Date: November 30, 2015
Rev.: August 16, 2016
Rev.: September 7, 2016

**Site Plan Review
For
Plymouth, Michigan**

Project Name: O'Reilly Auto Parts

Location: 874 Ann Arbor Road

Figure 1. Subject Site

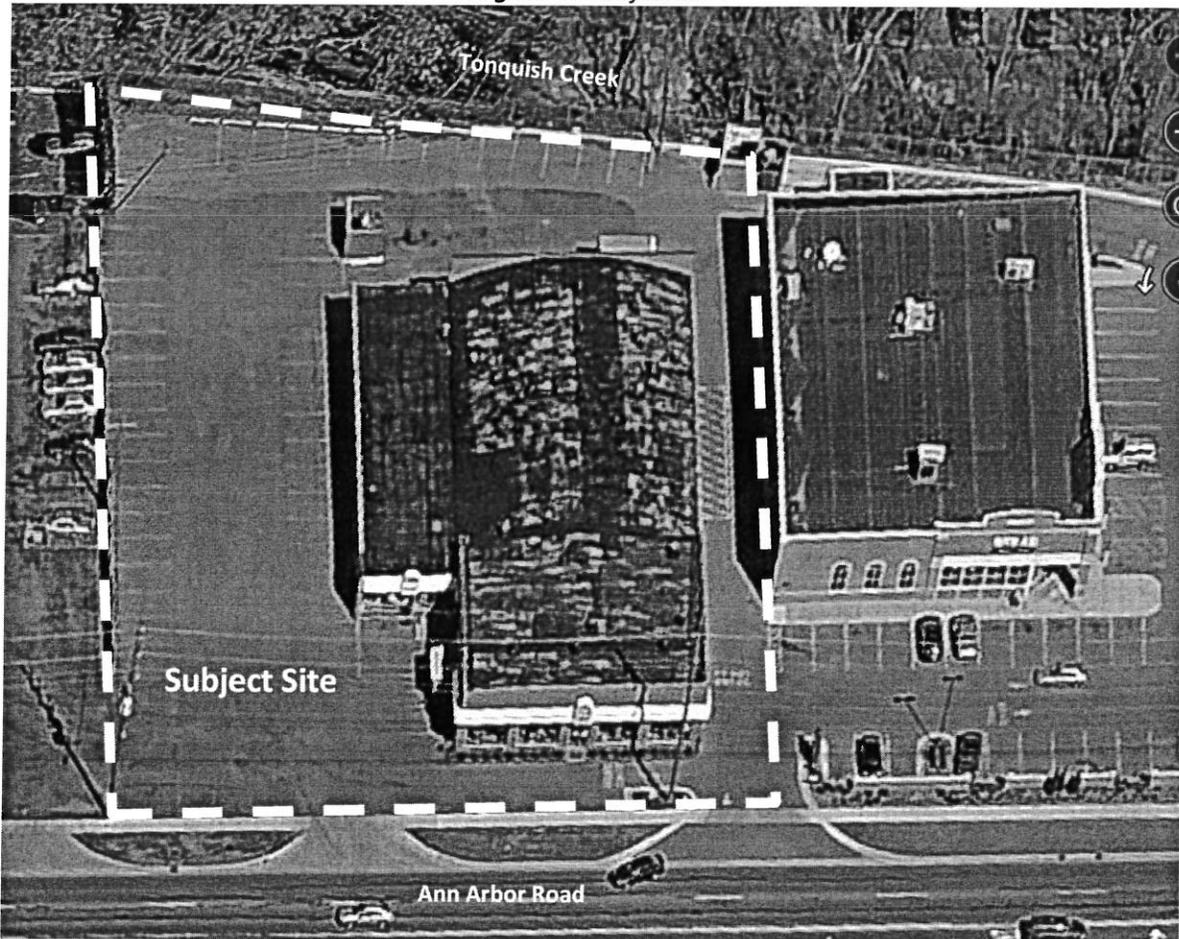
The applicant is proposing to remove approximately 6,900 square feet of the existing 13,900 square-foot building, and replace it with one commercial unit equaling 6,864 square feet. The property has two existing vehicular access points from Ann Arbor Road, which will be retained.

In addition, the Rite Aid Pharmacy to the east has an access easement on the subject site that accommodates the pharmacy's drive-through lane.
